## COUNTY ADMINISTRATOR'S OFFICE

October 18, 2018

### **Re: Response to Hudbay Regarding Intermittency and Surface Water Impacts**

Figure 1. Location of the two stage sensors in Barrel Canyon in relationship to alluvial deposits (green) and bedrock (red)<sup>4</sup>. Intermittent flow reach of Barrel Canyon<sup>5</sup> is noted in blue.

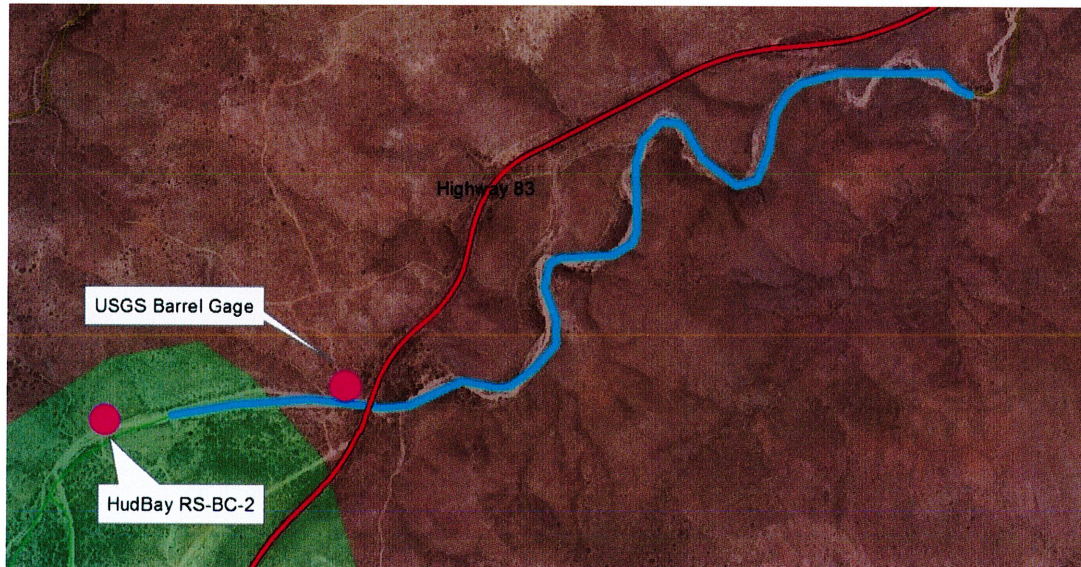
What is particularly relevant to this topic is that Hudbay’s flow (stage) sensor in Barrel Canyon (RS-BC-2) is actually located in alluvial deposits and further upstream of the Barrel Spring and USGS gages that demonstrate intermittent flow. Hudbay fails to mention this fact.

Despite this, it should be noted that by the company's own data in the January 25, 2018 letter, anything that is "Bank Storage" is flow, by definition, characteristic of intermittent or perennial streams because it is not associated with storm events.

Figure 2. Days of flow recorded at the USGS 09484580 Barrel Canyon gage at various times since 2015. Data are "Approved for Publication".

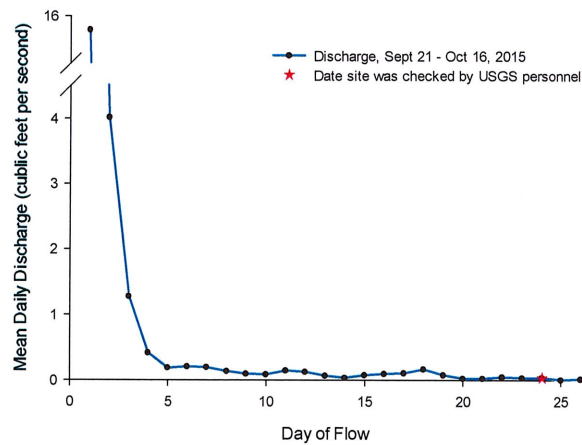
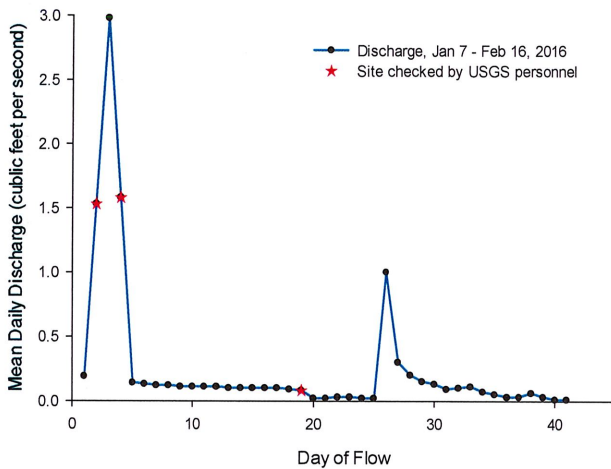
The USGS gage also provides important information showing intermittent flow on the Barrel Canyon. Figure 2 shows flow during three distinct periods of continuous flow since 2015 and Figure 3 shows Barrel Canyon on August 16, 2017, just downstream of the Highway 83 bridge.

Figure 3. Evaporative Demand Drought Index<sup>8</sup> graph showing the drought conditions (in red). Collection year for the stonefly is noted, but because of the biology of the species, its presence at the site in early 2010 is especially important because of the extremely dry conditions in 2009.

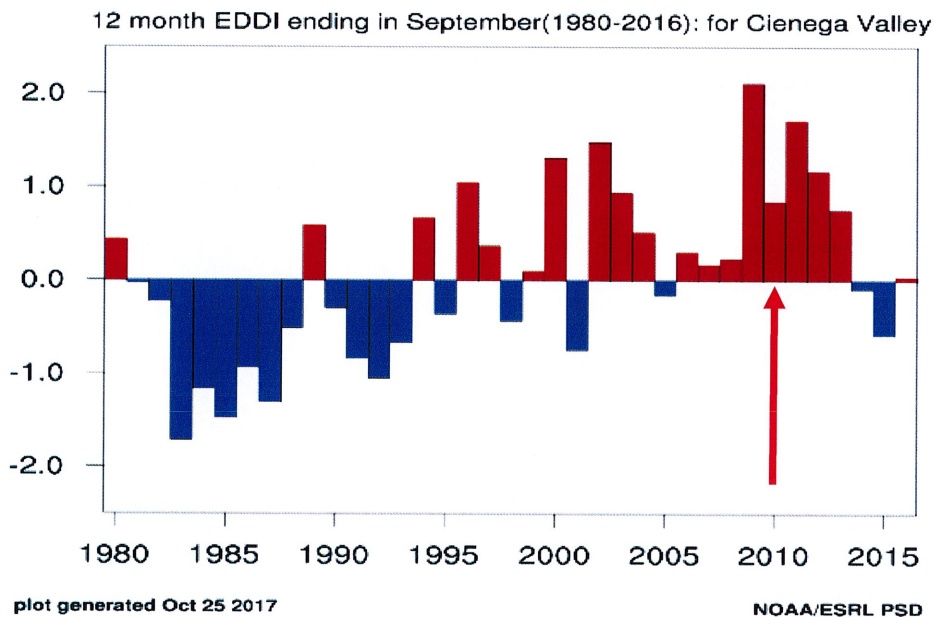
In April 2010, multiple specimens were collected in Barrel Canyon approximately 1500 feet downstream from the Highway 83 bridge and USGS gage<sup>7</sup>, near "Barrel Spring" where shallow bedrock likely enhances the expression of surface flow. The collection occurred just after an extremely dry three-year period (Figure 3), but heavy rains elevated groundwater levels and Barrel Canyon began flowing on January 22, 2010.

**Table 2 – Fraction of the Observed Flows Contributing to Davidson**

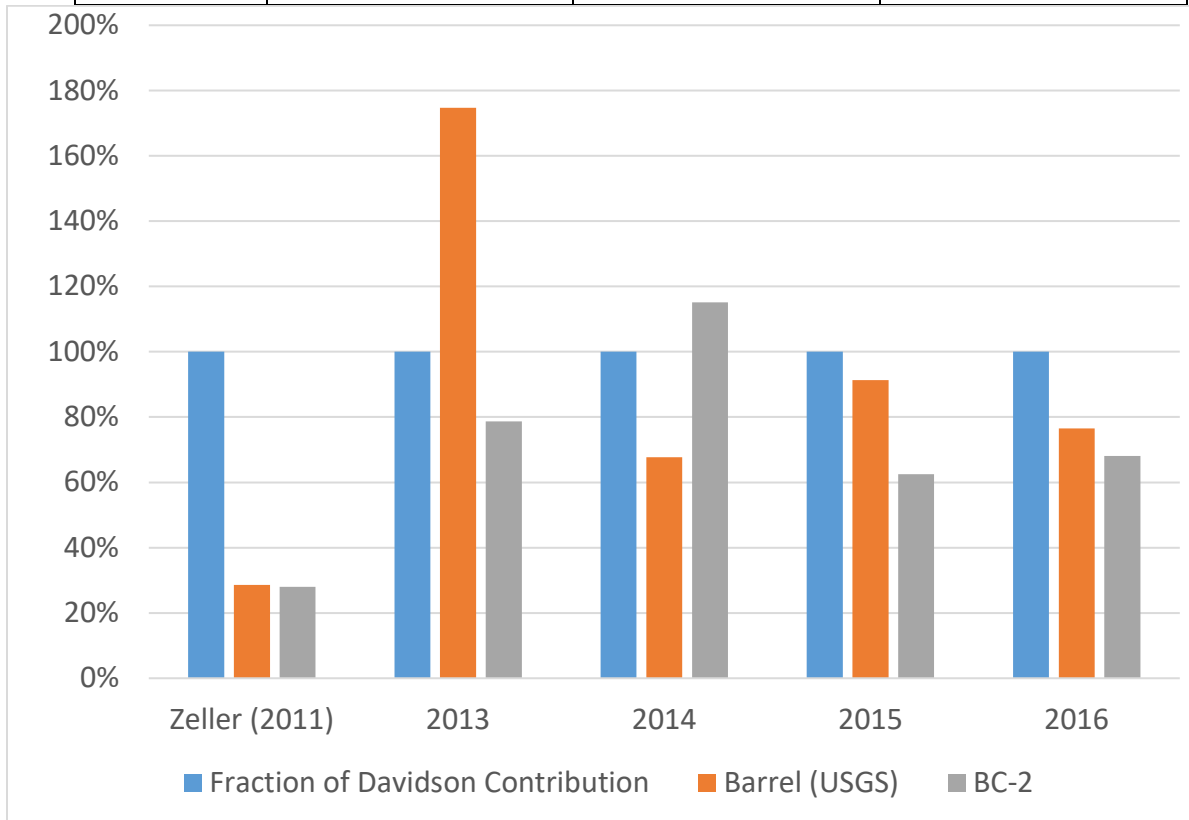
In fact, comparing the observed measurements for the period from 2013 to 2016 (based on data in Table 1), the fraction contributing from Barrel is always more than half of the observed flow at Davidson (Table 2 and Figure 1).

However, their consultant’s datasets attached to the transmittal letter confirm that flows from the mine site to Davidson Canyon are significantly higher than predicted by the Zeller method, and the estimate of 4.3% reduction in flows to Davidson indicated in SWCA 2012. Outflows predicted by the Zeller method cannot be considered “conservative” based on the observed data. Barrel watershed’s observed outflows during 2013-2016 provided more than half of the observed flows to Davidson.
